Memorandum

Date: April 24, 2025	
To: Brian Froelich, AICP	Organization: City of Capitola
From: RRM Design Group	Title: Design Review Team
Project Name: Capitola On-Call Architectural and Landscape Review	Project Number: 1783-09-PP25
Topic: 506 Pine Street Review

Site Plan

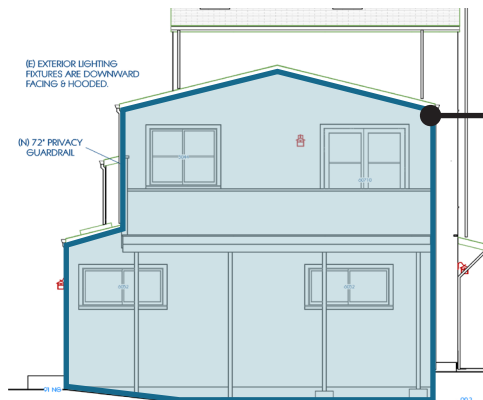
The applicant should remove guest parking spaces from the plans as the proposed locations will cause ingress and egress issues for residents needing to access the detached unit/duplex garages.

Revise the site plan to include pedestrians walkways connecting the public realm and proposed primary entries to provide safe connections for residents and guests.

Detached Unit South Elevation

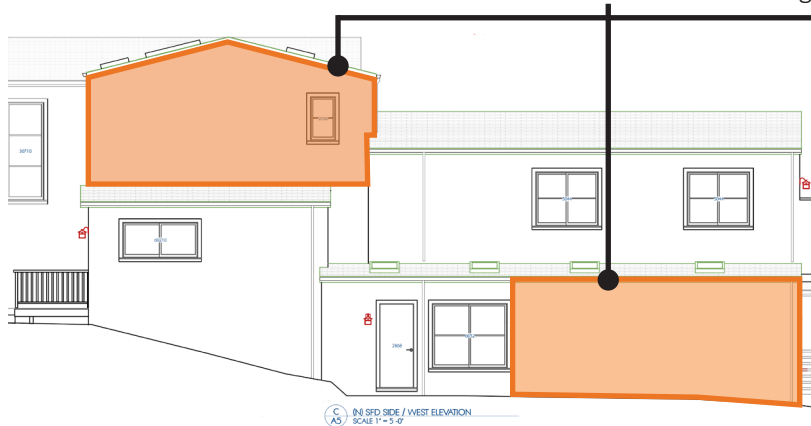
Incorporate a minimum of two façade design strategies per OS 17.82.080.B.3 in a manner consistent with the selected style. Potential solutions include introduction of an additional material on the ground floor similar to the wood paneling on the existing duplex, providing a porch, and/or any additional design intervention that improves the street facing elevation.

Detached Unit West Elevation

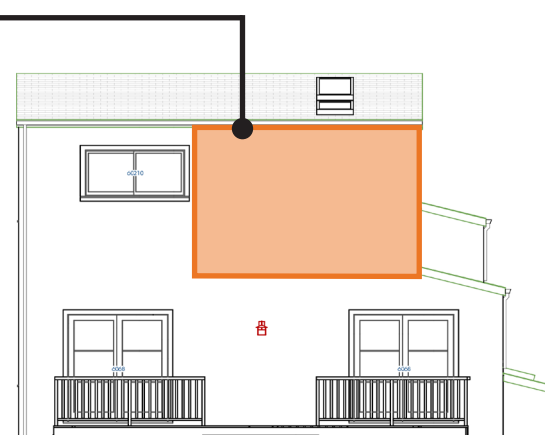
Revise the west and north elevations of the detached unit to remove large unarticulated blank wall space per OS 17.82.080.B.1.a. Potential solutions include additional windows, architectural detailing, variation in wall plane, and/or any design intervention that positively impacts the proposed detached unit street facing elevation.

Existing Duplex On-Site

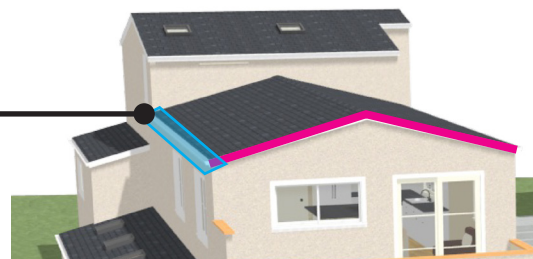
Applicant should match the pitch of the detached unit and duplex addition to the existing duplex. Similarly, utilize the same eave overhang shown on the existing duplex on the proposed detached unit as this design feature is consistent with the selected California Ranch architectural style.

Rendering of Proposed Detached Unit

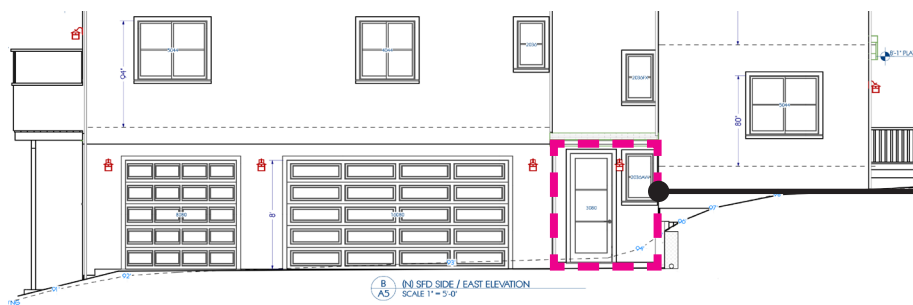
A primary entry contributes to the overall identity of a building by defining the architectural style and engaging with the public realm. While the applicant has minimally emphasized the primary entry of the proposed detached unit, the entry faces inward and is not visible from the public realm. The applicant must revise the floor plan of the detached unit to provide a street facing primary entry and further solidify the connection with the public realm to be in compliance with OS 17.82.060.B.3.b and Figure 17.82-3. The applicant may opt to seek director approval for entry exceptions instead of revising the floor plan per OS 17.82.060.B.3.c, however, this path would require the applicant to satisfy the following requirements: one pedestrian walkway per fifty feet of property street frontage connecting the adjacent sidewalk to the interior of the lot; landscaping between the residences and street; street facing buildings not exceeding a width of 100 feet. The applicant has minimally provided awnings/coverings in an effort to emphasize primary entries on the detached unit and existing duplex addition. However, to further establish and delineate the primary entries for future users, primary entries must include a porch, covered entry, or recessed entry clearly visible from the street (OS 17.82.060.C.1.a).

Detached Unit East Elevation

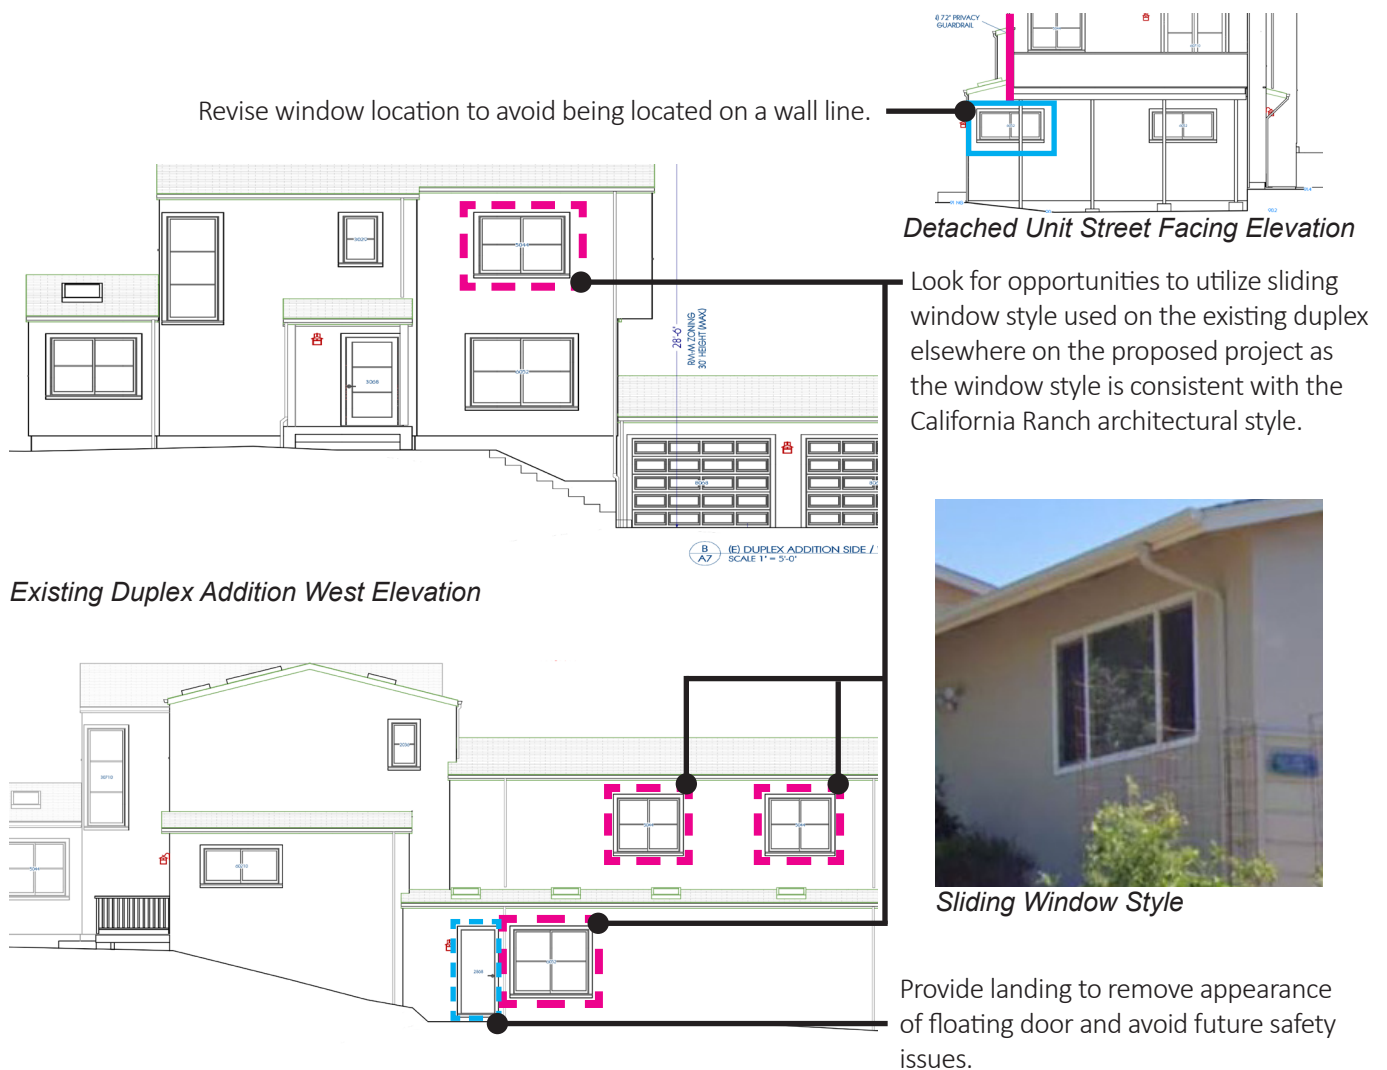
The applicant must revise the floor plan to relocate the primary entry of the detached unit to be street facing to establish a connection with the public realm (OS 17.82.060.B.3.b).

Site Plan

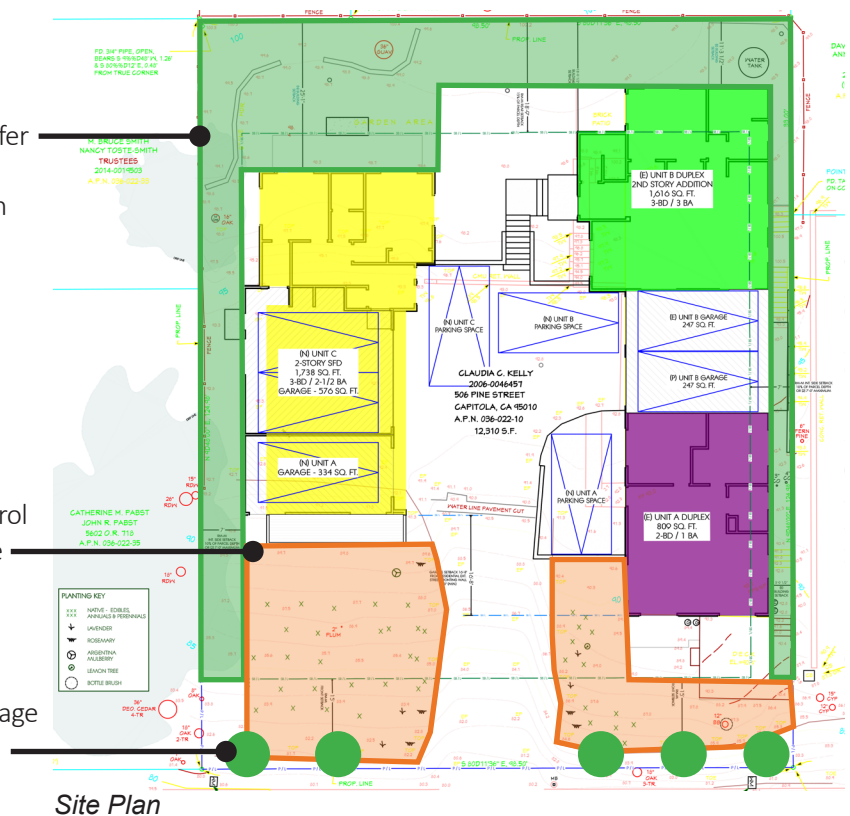
The applicant has provided a Landscape Plan on Sheet A11 with a preliminary plan showing the existing and proposed vegetation. However, the Landscape Plan should provide plant symbols which accurately reflect the width the vegetation will grow and a circle is recommended for trees and shrubs to better reflect the ultimate size the plants will grow (17.72.040 B.6). The tree diameter of existing trees are provided on the Landscape Plan; however, outer limit of tree canopy should be included and a label identifying if the existing trees will remain or be removed (17.72.040 B.5).

In general, the landscape design has an appropriate sense of unity, proportion, and balance with generally harmonious colors and durable plant species. The vegetation appears to be primarily drought-tolerant and generally reflects the "California Ranch" character. However, the Planting Key should list the genus and species of all proposed plants (17.72.040 B.6). In particular, the Native – Edibles, Annuals & Perennials must provide a list of the vegetation that is proposed. Additionally, the water use for each plant should be included in the Planting Key to understand the exterior water requirements for the project and to ensure compliance with the water use efficiency ordinance (17.72.030). Ensure a minimum of ninety percent of plants and trees are drought-tolerant (low or very low water use) as defined by the Water Use Classification of Landscape Species - WUCOLS (17.72.060 A.1).

Consider including fast growing evergreen buffer species between existing adjacent residential homes and proposed second story addition on Unit B and the new Unit C.

Look for opportunities to include erosion control groundcover and shrubs along the steep slope areas to reduce erosion.

Consider including street trees along the frontage to increase the amount of shade along Pine Street.
